## Release Notes

### EOSPRINT 2.15.1249.0

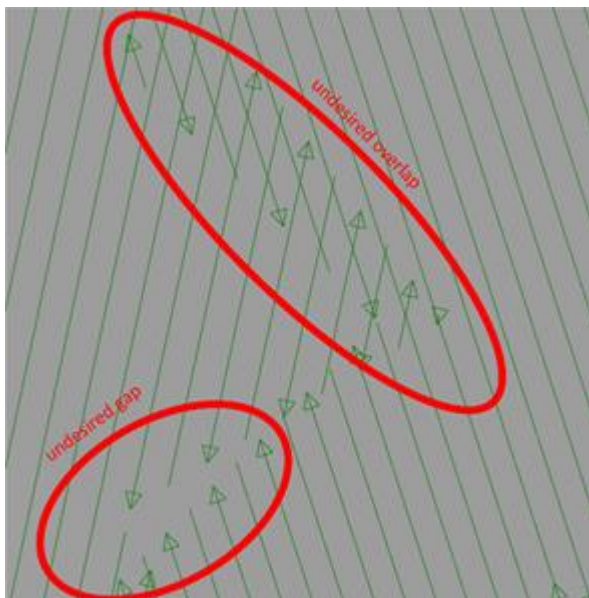
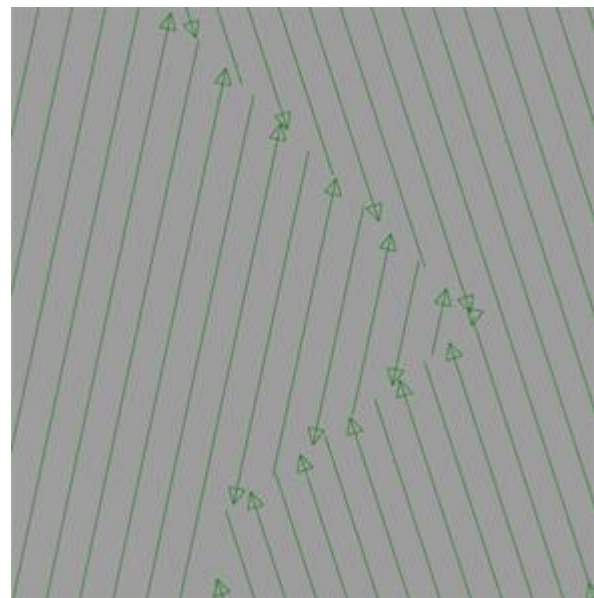
- Item 148710: EOSPRINT introduces very small delays at certain points in the exposure to compensate for the scanner's tracking error. In previous versions, these delays were not taken into account when estimating the building time. Each delay is only a few  $\mu$ s, but since there can be many such delays per layer, the times can add up. The problem has been fixed, and thus the estimated building time is now more accurate.

The change may also affect the Minimum Vector Time feature used for energy input homogenization in stripe exposure.

This feature predicts the exposure time of scan vectors in stripes using the same algorithms as the building time estimation and introduces delays if the user-defined minimum vector time is underrun. Since not all existing delays were considered in the building time estimation, the realized minimum vector time could be a few  $\mu\text{s}$  longer than specified by the user in the parameter editor. In general, this resulted in a slightly lower energy input than intended. Due to the now correct estimation of the exposure time, the minimum vector times and thus also the energy input match the values defined by the user.

This change is relevant to the building process. EOS considers the differences to be negligible, but no guarantee can be given for this.

This has been fixed.

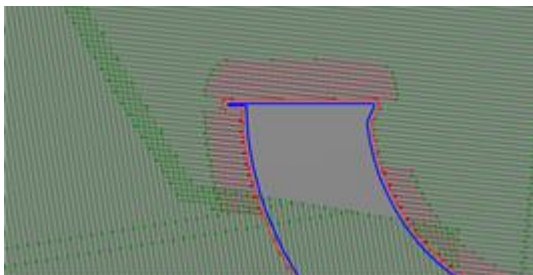
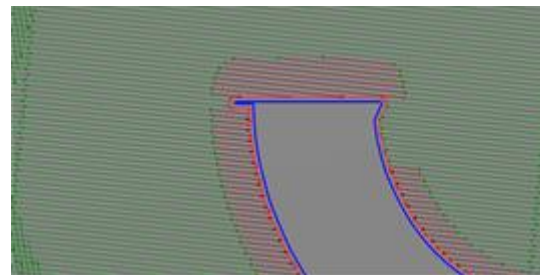
- Item 128749: In rare cases, laser power & scan speed were not reset after a downskin exposure with the material sets 1.2709\_040\_HiPerM291, 254\_040\_CoreM291 and 254\_060\_CoreM291. In these cases, the exposure continued until the next power or speed change was requested and applied. The below illustration visualizes this behavior. The vectors are processed according to the indicated stripe direction. Green vectors denote infill, black vectors downskin. In the example, the laser power is not reset after the last downskin vector. Thus, subsequent (dashed) vectors are exposed with the same power as the downskin before. In the example, the problem persists until the next real downskin vector is reached, which sets the laser power again so that the subsequent vectors are exposed correctly.

The problem was not noticeable to EOSPRINT users, but a connected EOSTATE Exposure OT or EOSTATE MeltPool system would detect and report it during the building process. The problem is now fixed. This change may influence the building process and thus the part quality.

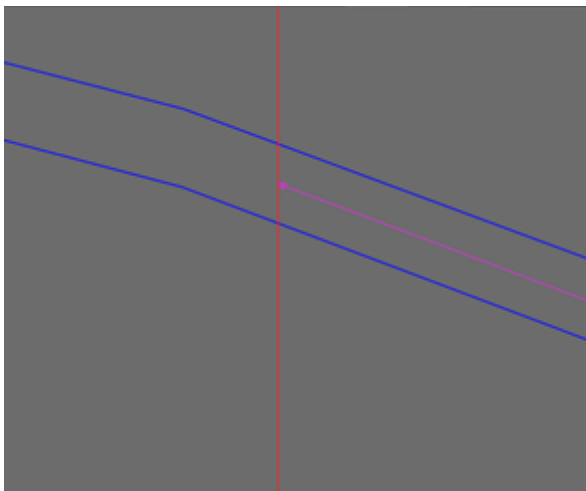
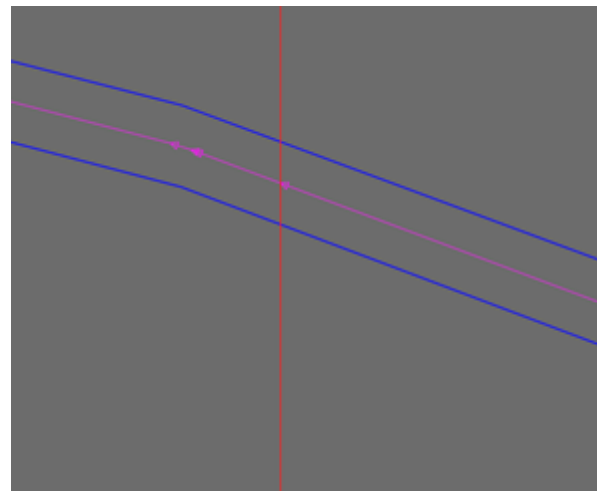
- Item 136250: In some cases EOSPRINT crashed when applying an automatic part exposure order with the tool **Part Exposure**. The problem is resolved.
- Item 73378: If a SLI or CLI file contained only a single slice, then this slice was not exposed. Jobs containing only such single-layer SLI/CLI could not be exported because EOSPRINT did not find any exposed layers. This problem is now fixed. This change may influence the building process and thus the part quality.

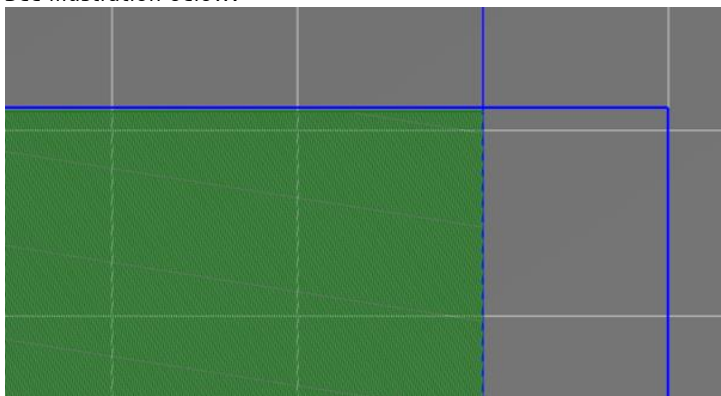
- Item 113257: If a part with manual laser assignment was placed very close to the scan field boundary of its assigned laser, it could happen that the part was scaled beyond this scan field due to the configured machine-specific shrinkage compensation. As a result, areas of the part that were now beyond the scan field boundary were not exposed.  
For a better understanding, the problem can be reproduced as follows in EOSPRINT 2.9 and earlier:  
Load a cube geometry into the building envelope of a multi-head system, e.g. the EOS M 400-4. Place the cube so that it abuts the scan field boundary marked in blue. In the illustration to the right, the red cube lies completely in the overlap area of lasers 1 and 4 and its right side abuts the boundary of the scan field of laser 4. Now manually assign the part to the laser whose scan field boundary it abuts (here: laser 4, bottom left). Connect to a real system and set a shrinkage compensation in the tool **Upload Fine Tuning**, so that the part is scaled beyond the scan field boundary. With reference to the example, e.g. an X scaling of 10%. Then look at the part in the preview. You will notice that the scaling has scaled the part beyond the scan field boundary and no vectors have been created for the portion of the area that can no longer be reached by the assigned laser.

See illustration below:

EOSPRINT will now detect such problems upon task export and issue an appropriate warning that also suggests possible solutions.

### DEFECTIVE CALIBRATION

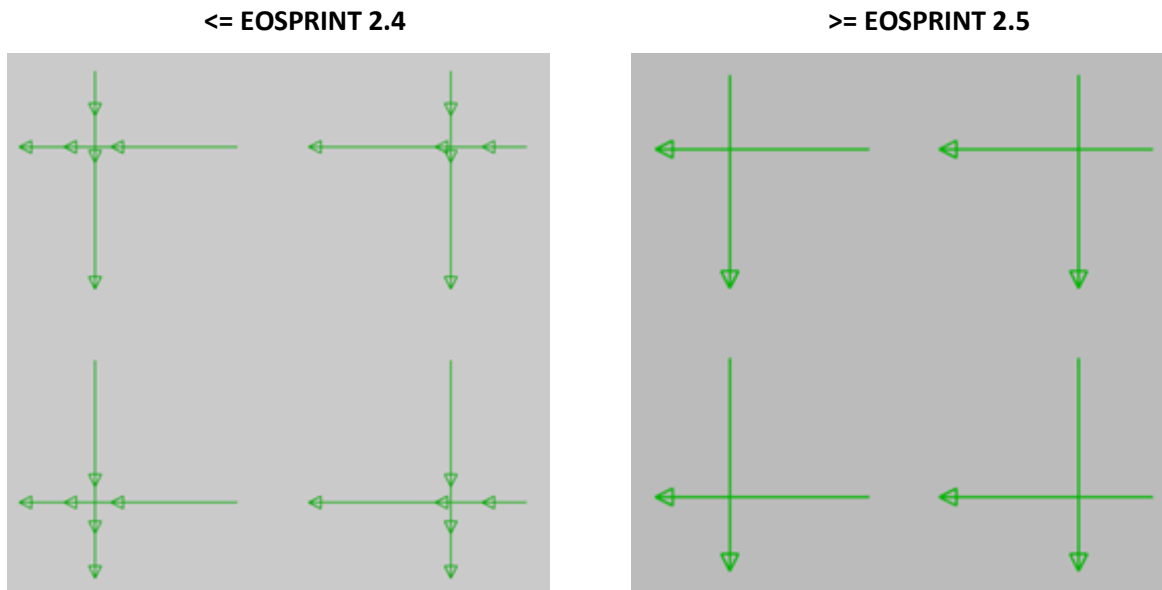
- In EOSPRINT 2.4 as well as in earlier 2.x versions, fine tuning parameters such as the global beam offset, and the X/Y scaling could not be set machine-specifically. As a workaround, the fine tuning parameters were set via EOSPRINT 1. EOSPRINT 2 then merged these parameters stored on the machine with the default jobs into machine-specific material sets.  
Since EOSPRINT 2.5, machine-specific fine tuning parameters are no longer merged with the material sets. Machine-specific material sets, and jobs based on such material sets can still be loaded in EOSPRINT 2.5 and newer. In rare cases, however, problems may occur, and the loading is aborted with an error message indicating a defective calibration:
